STATE OF CONNECTICUT
CONNECTICUT SITING COUNCIL

IN RE:	:	
	:	
APPLICATION OF CELLCO PARTNERSHIP	:	DOCKET NO. 494
D/B/A VERIZON WIRELESS FOR A	:	
CERTIFICATE OF ENVIRONMENTAL	:	
COMPATIBILITY AND PUBLIC NEED FOR	:	
THE CONSTRUCTION, MAINTENANCE	:	
AND OPERATION OF A WIRELESS	:	
TELECOMMUNICATIONS FACILITY OFF	:	
CHESTNUT HILL ROAD, WOLCOTT,	:	
CONNECTICUT	:	NOVEMBER 13, 2020

**UPDATED RESPONSES OF CELLCO PARTNERSHIP D/B/A VERIZON WIRELESS
TO CONNECTICUT SITING COUNCIL PRE-HEARING QUESTIONS, SET ONE**

SHEET TITLE:
OVERALL SITE PLAN

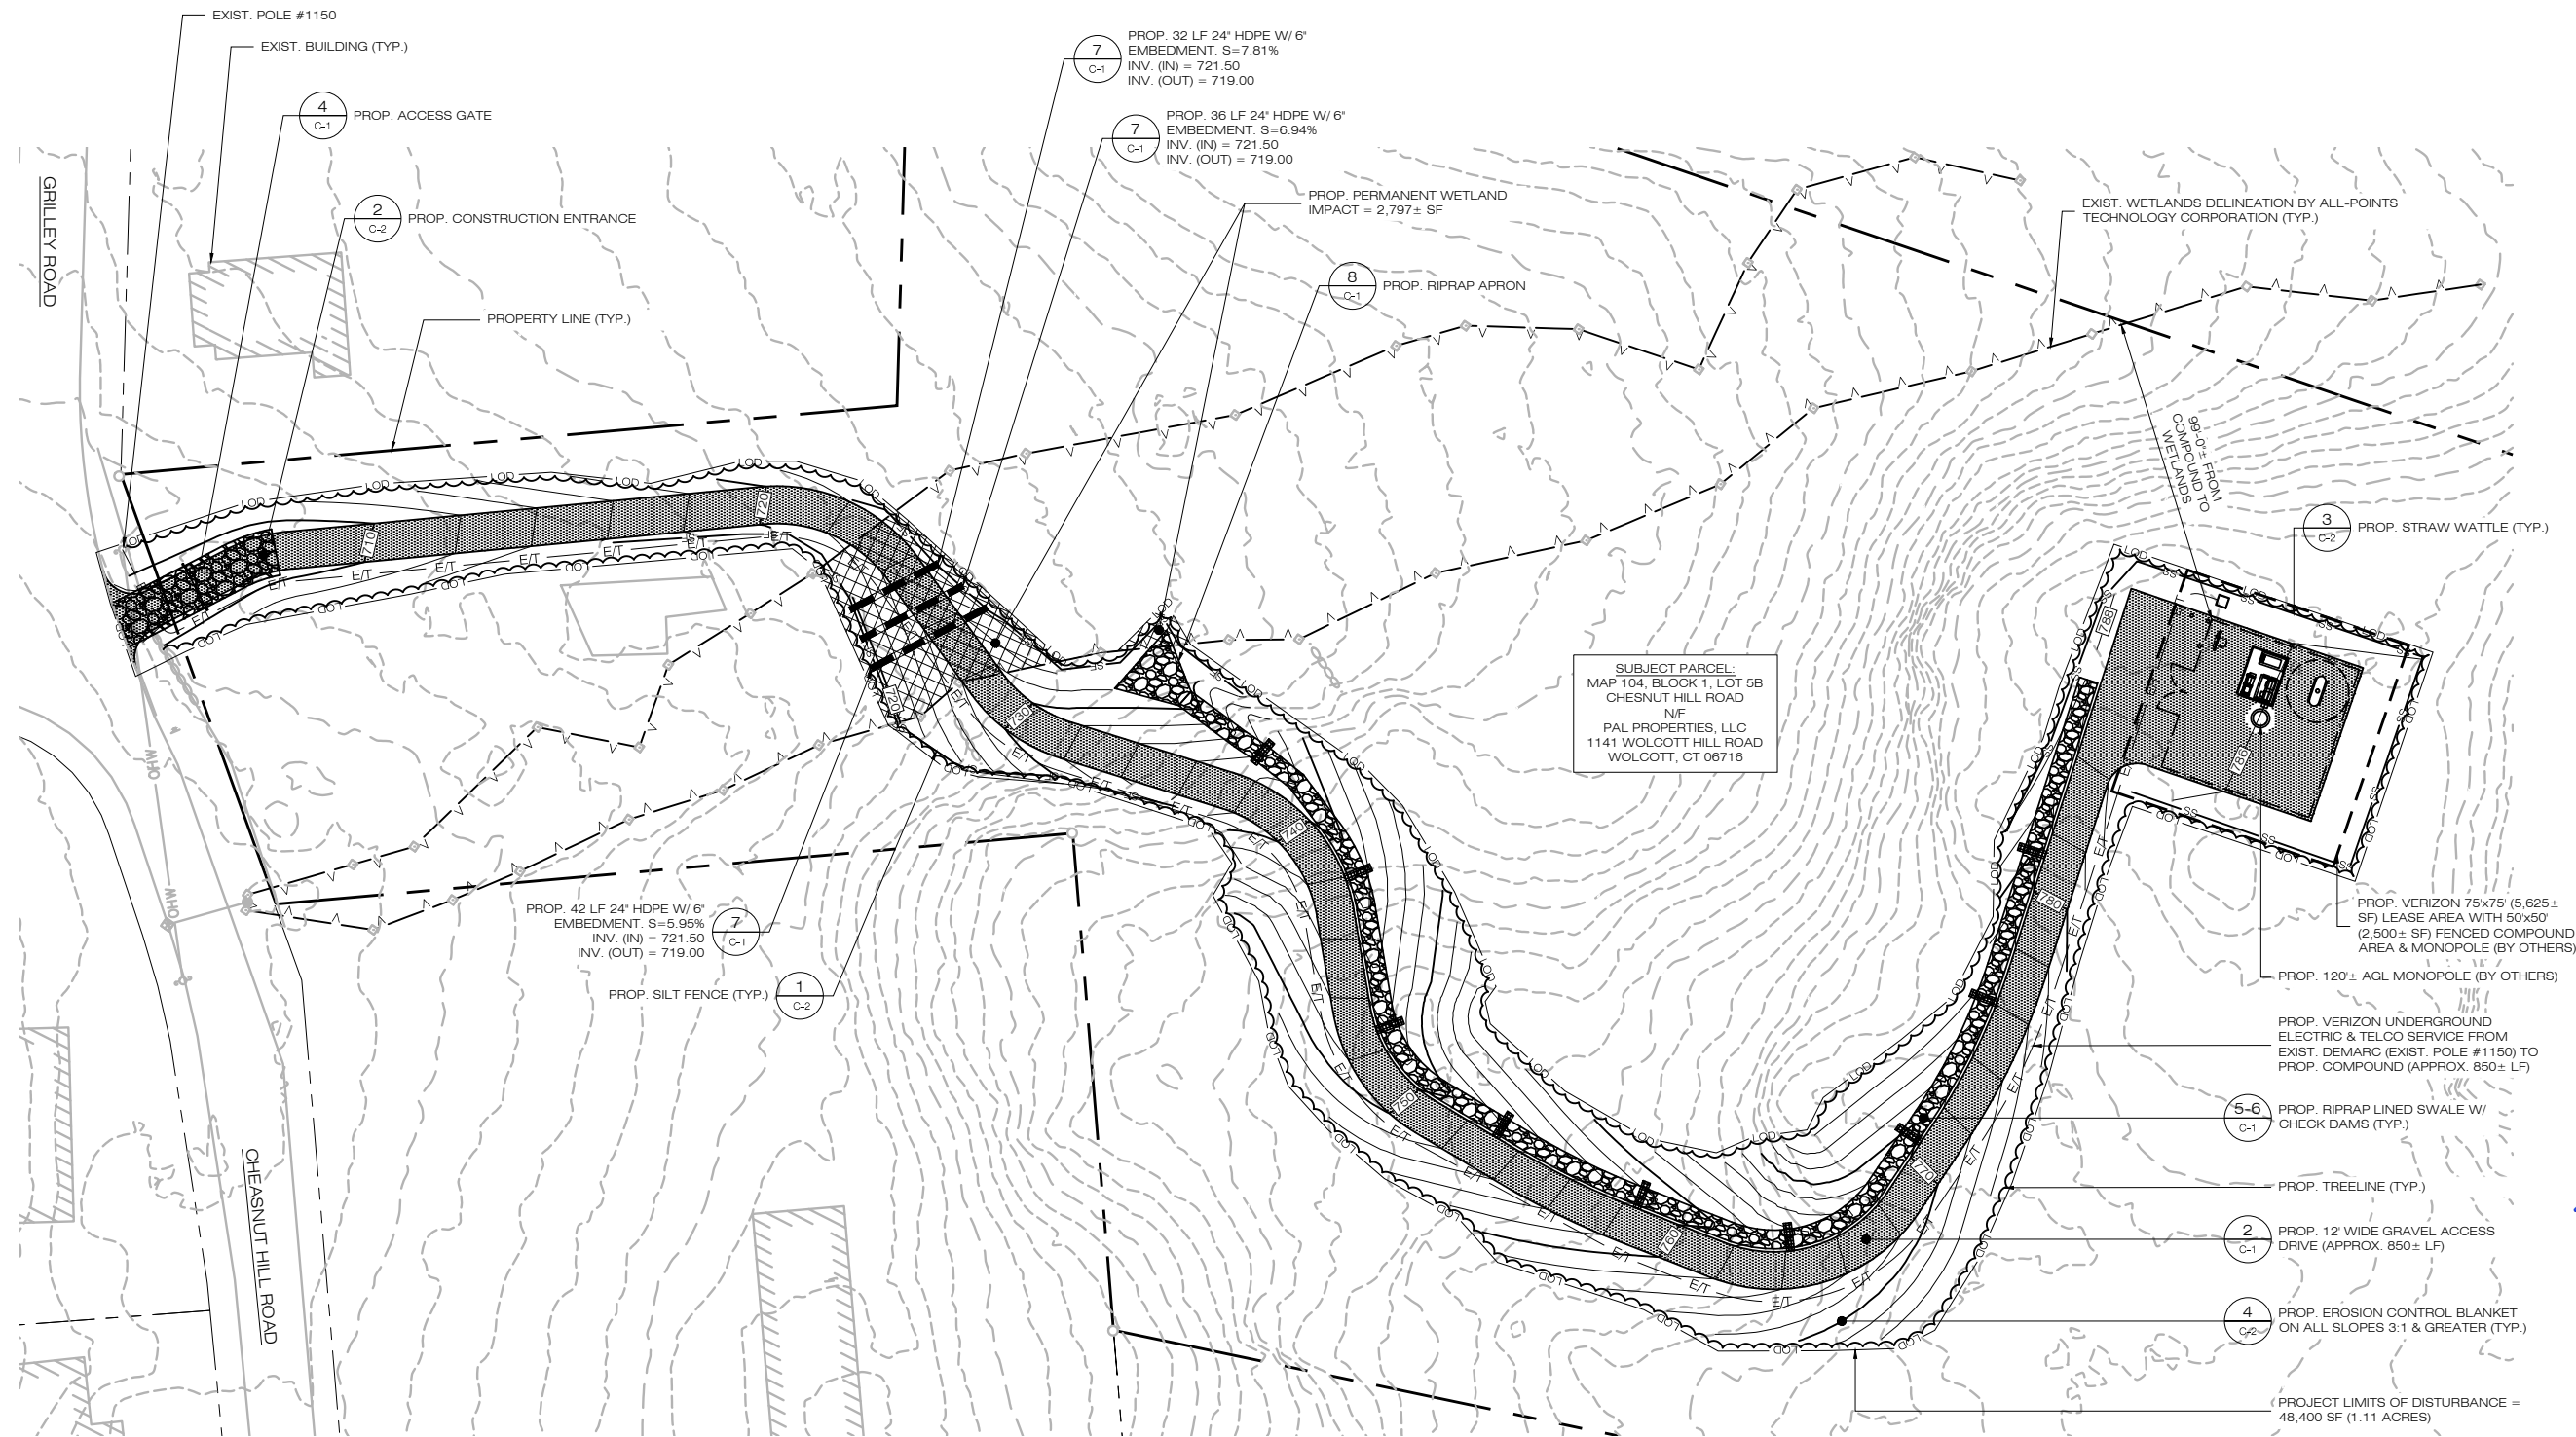
Referencing page 8 and Site Evaluation Report in Tab 1 of the Application, Cellco notes that the proposed access drive would be about 650 feet long. Referencing Sheets OS-1 and SP-1 of the Application, the proposed access drive is noted as 850 feet long. Please provide the correct access road length and include corrected sheet(s) if necessary.

The proposed access drive is approximately 850 feet long.

Core Forest Map

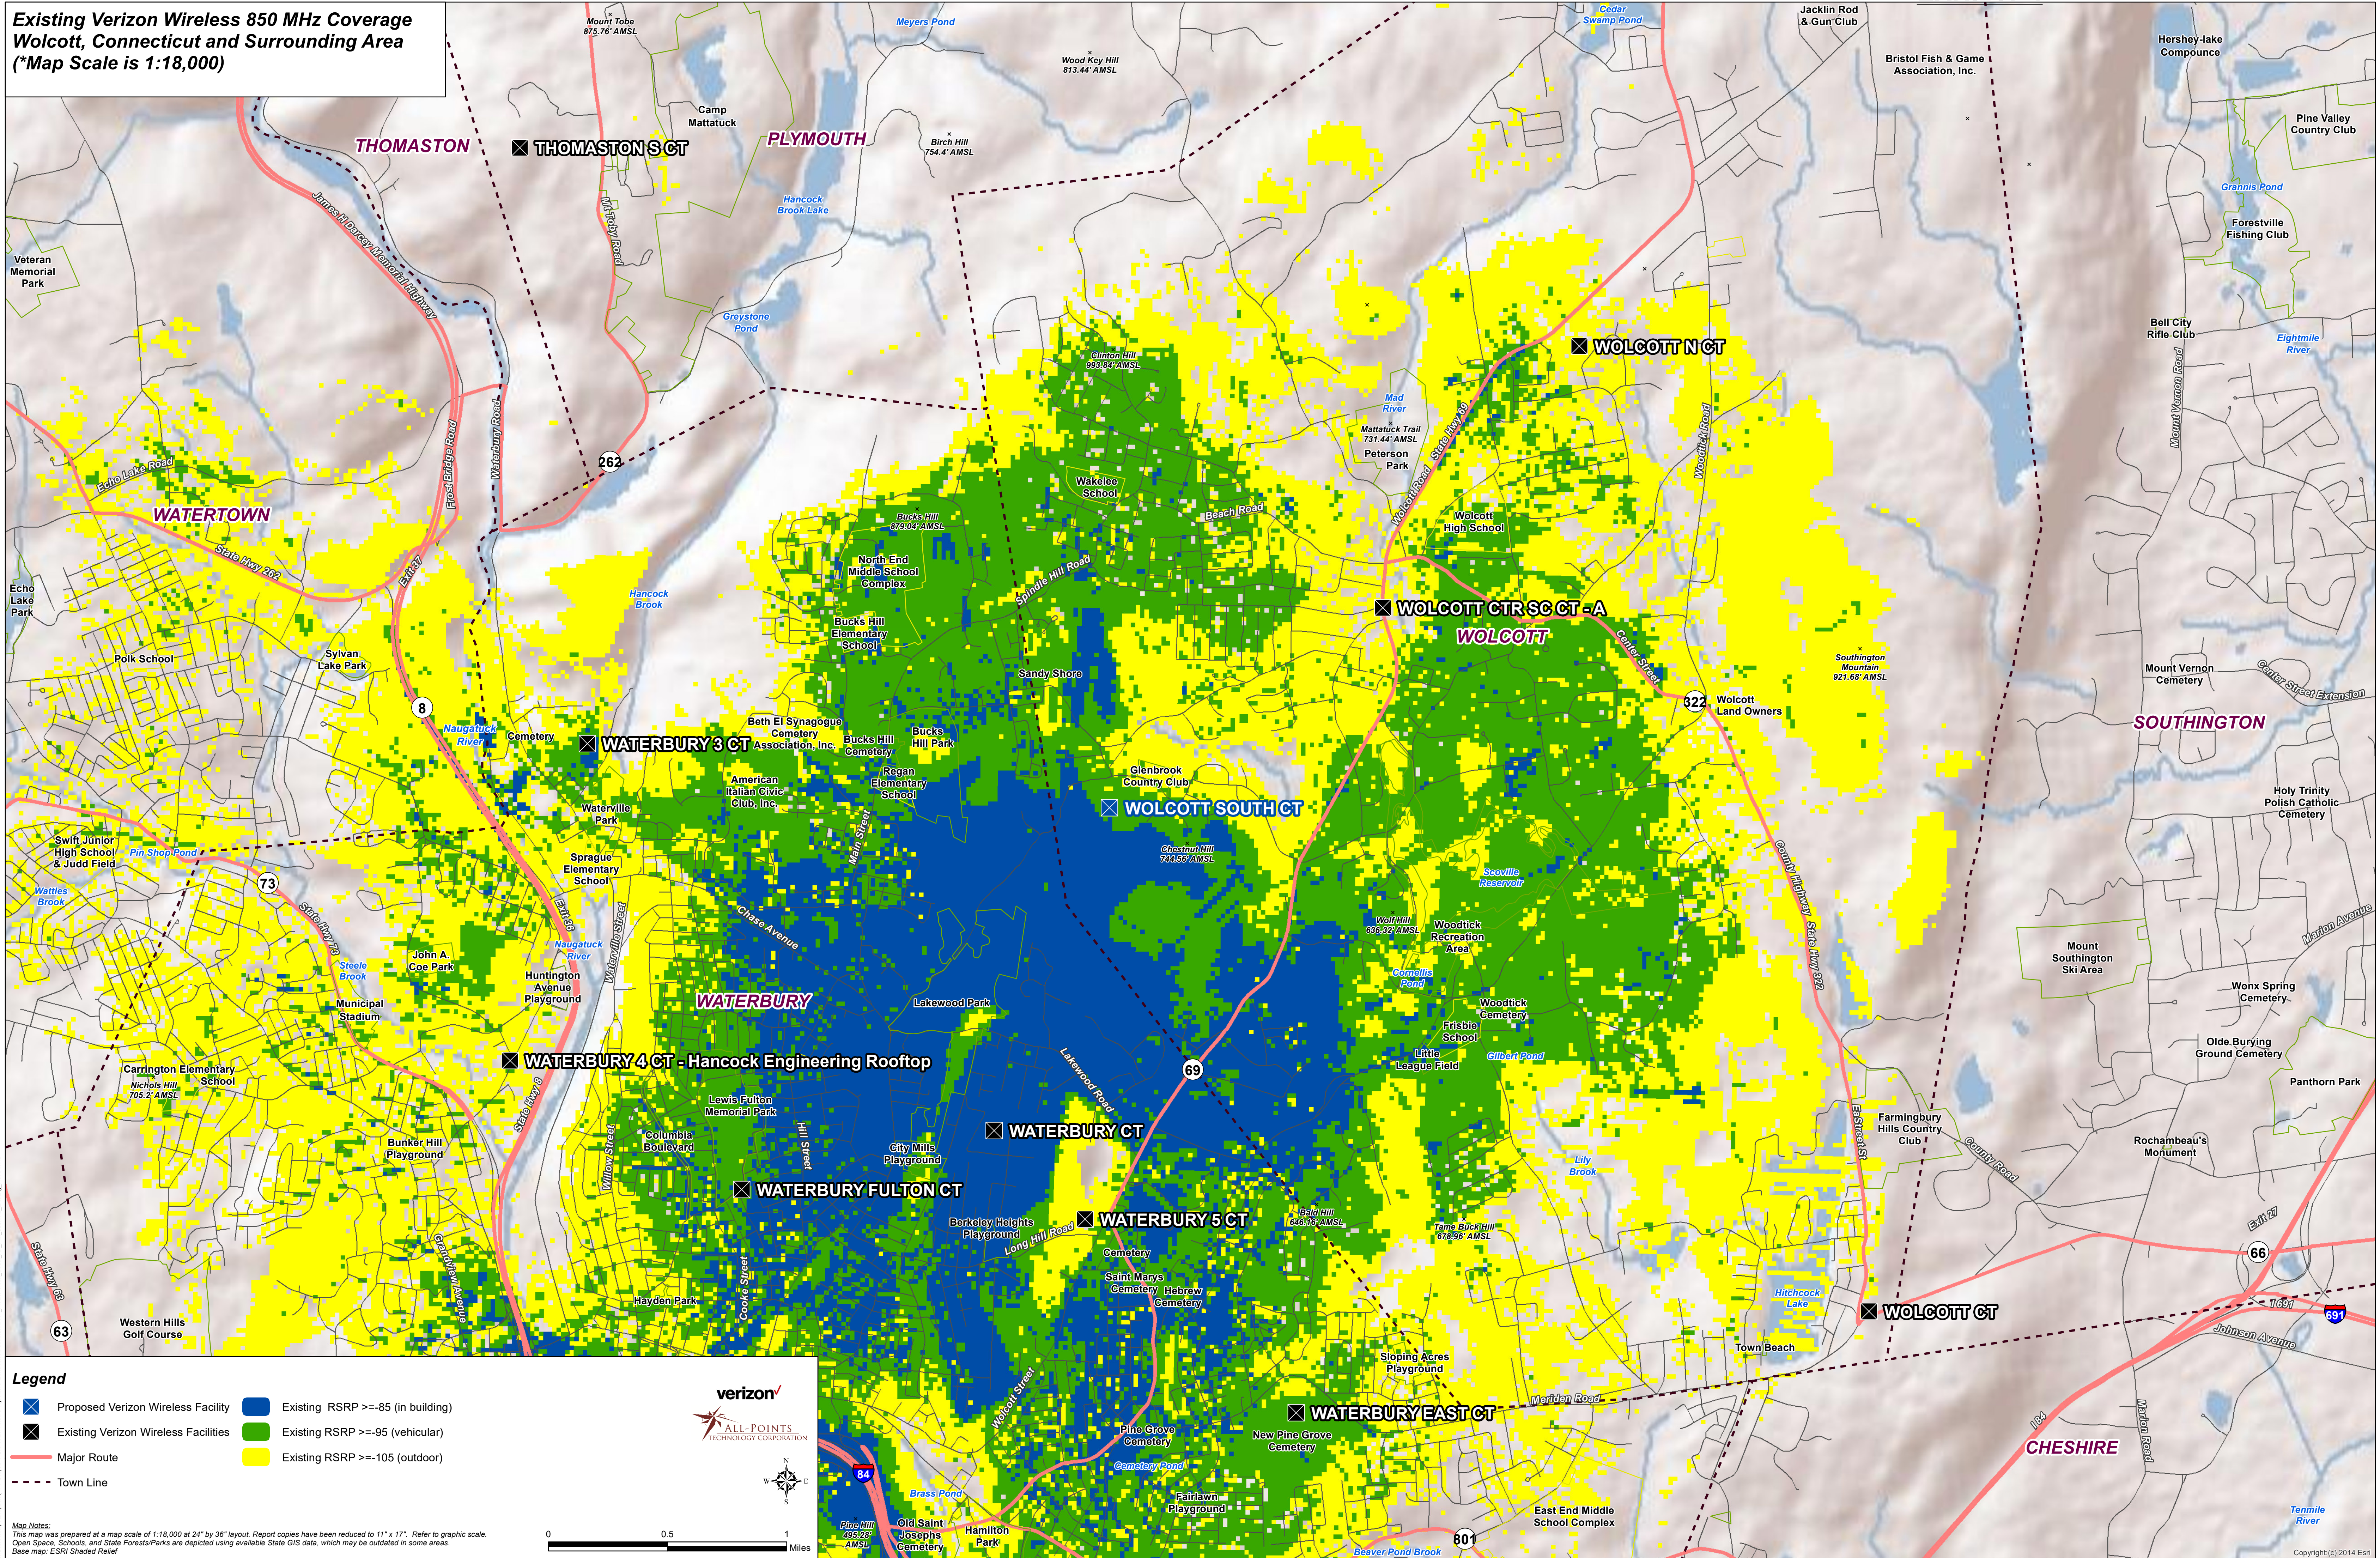
Would any tree clearing occur within core forest? If so, how many acres? Under Connecticut General Statutes §16-50k, “Core forest” means unfragmented forest land that is three hundred feet or greater from the boundary between forest land and non-forest land, as determined by the Commissioner of Energy and Environmental Protection.” How would tree clearing affect core forest? If applicable, provide the pre-construction and post-construction areas of core and edge forest at the site.

A portion of the proposed access drive would be located within an Edge Forest and the proposed tower compound and a portion of the access drive near the tower compound would be located within a small Core Forest block. Tree clearing is required within these two different forest categories as follows: Edge Forest – approximately 0.59 acres and Core Forest - 0.35 acres. Please refer to the enclosed Core Forest Map provided in Exhibit 3.
